REVISION LOG

Redlines Completed 10-Mar-24 (DP)

The Apex - RH 'GEORGIAN'

Cover Sheet 'Georgian'

SCALE:
1/8" = 1'-0"
SHEET
0.0b

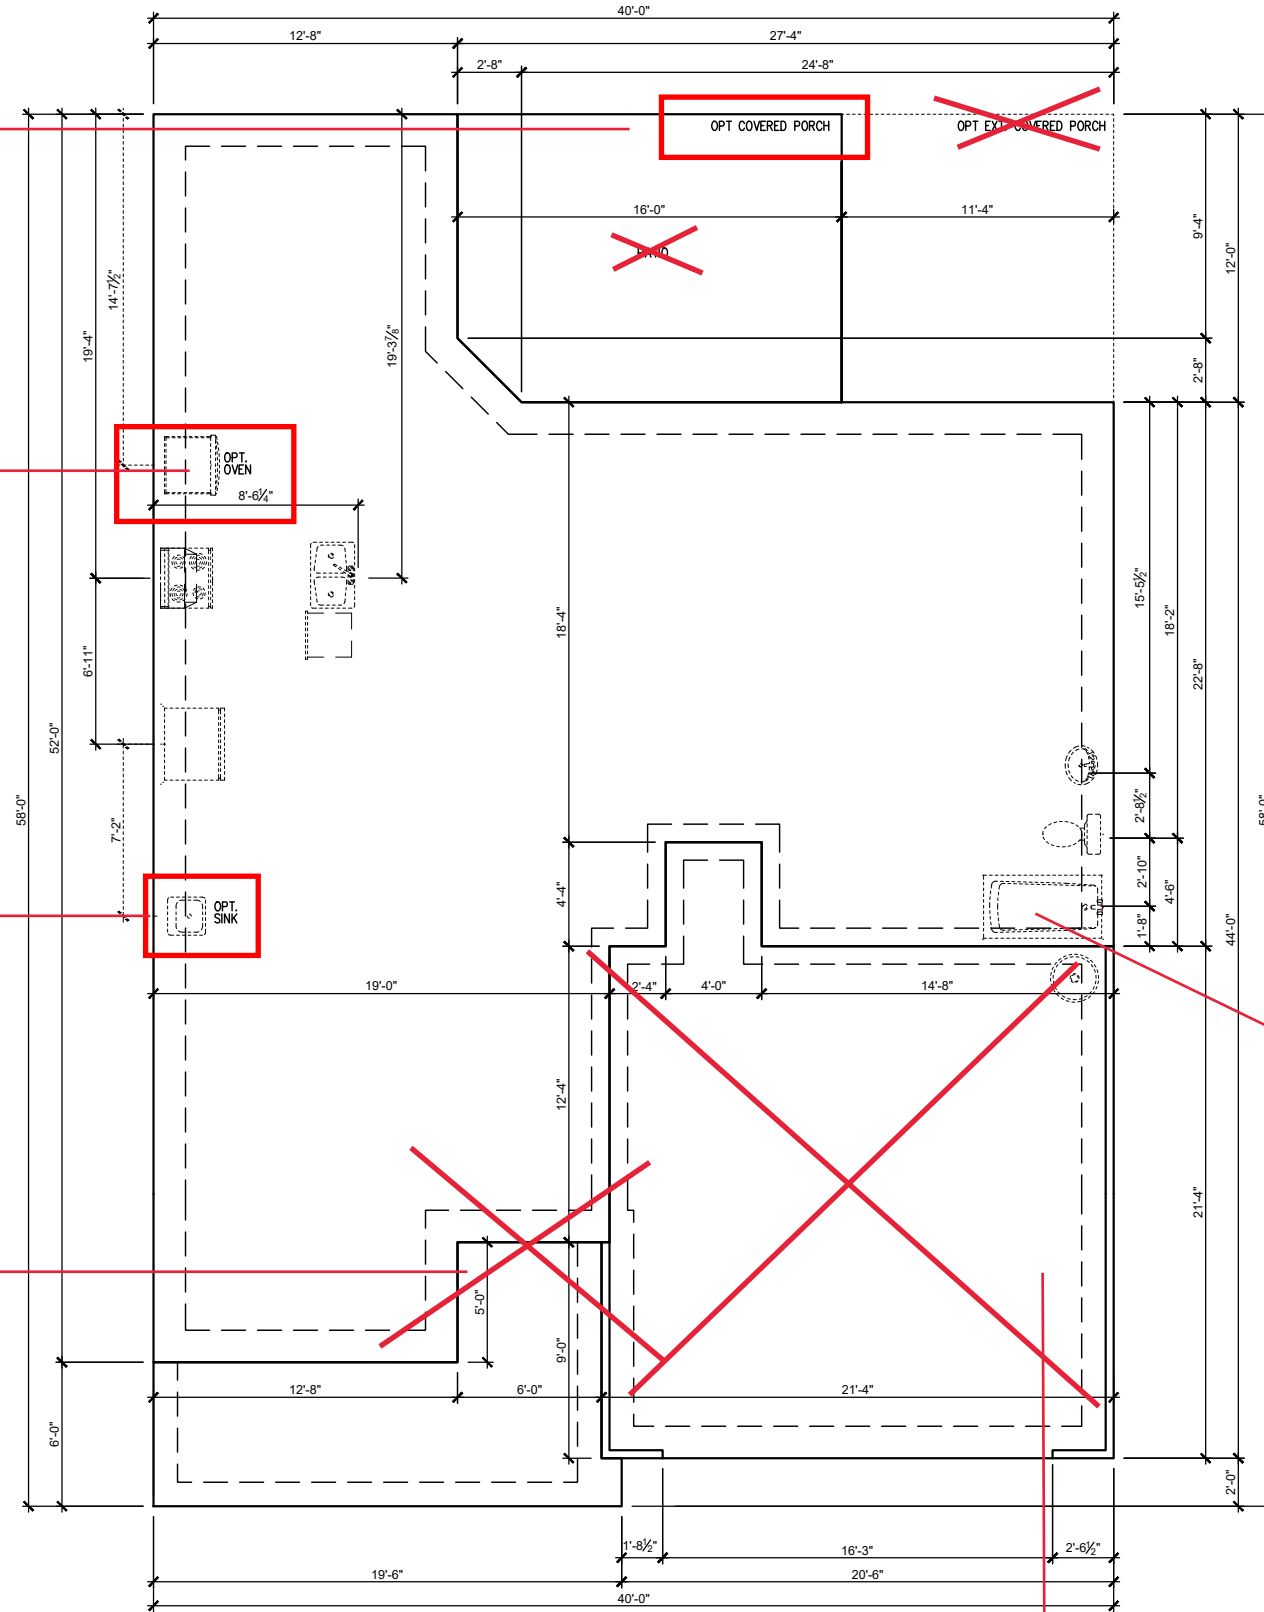
Gourmet Kitchen ←

Adding Sink at Messy Kitchen ←

Shower ILO Tub/Shower →

SECOND FLOOR PLAN 'GEORGIAN'
SCALE: 1/8"=1'-0" ON 11x17, 1/4"=1'-0" ON 22x34

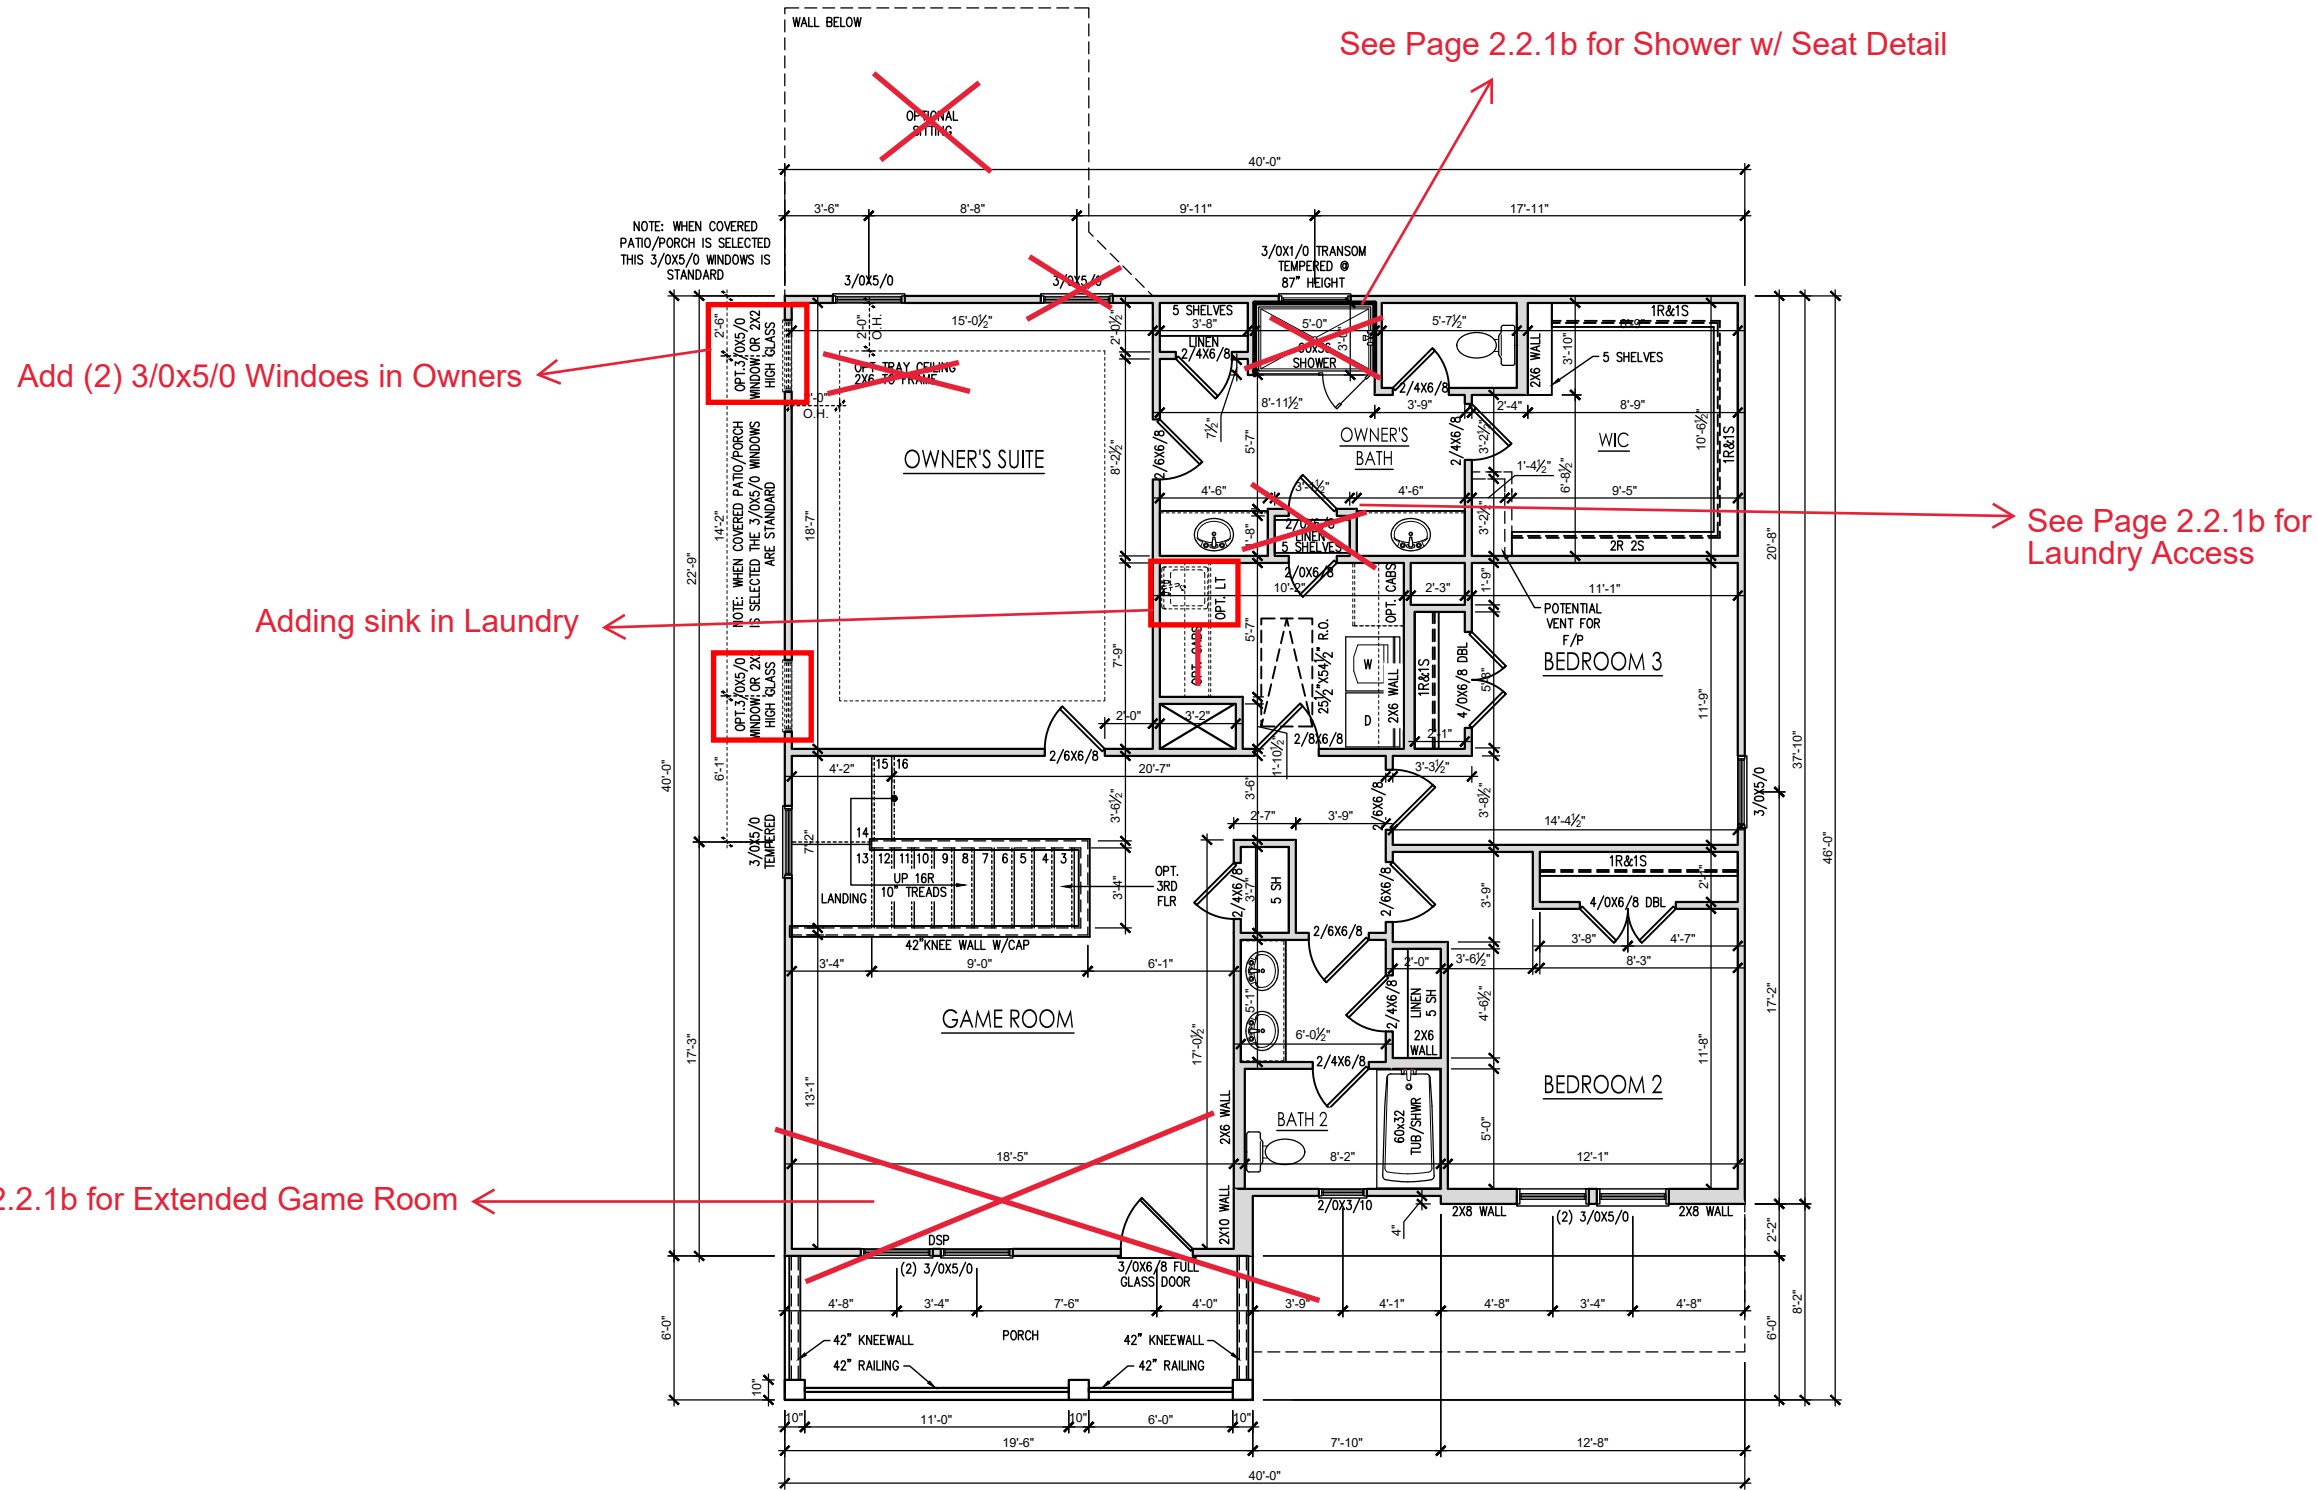
Add (2) 3/0x5/0 Windows in Owners ←

Adding sink in Laundry ←
